Product hierarchy no. *				Part no.	SBU	Product Type	Customer part no.
SBU	PG	PUG	Type				
03	070	010	0000003400	See list/appendix below	Switches	MCS16	
03	070	010	0000003400	See list/appendix below	Switches	MCS19

Plating material of the contact pins has been changed from tin to silver.

Product Change Notification					PCN MCS - Material change		
owner	creation date	release date	released by	change order no	rev	page	D10-062-773
ghezziisa	07.03.2022	10.03.2022	riedlan	2023640	B	1 of 2

Current product appearance	New product appearance
Tin (Sn)	Silver (Ag)

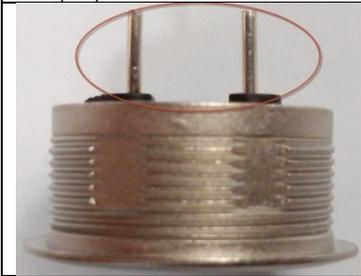
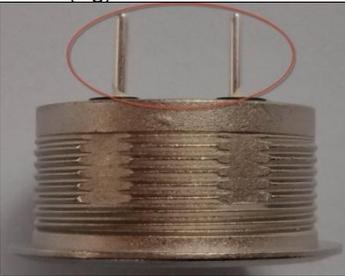
- Change of surface plating material on pins from tin to silver.
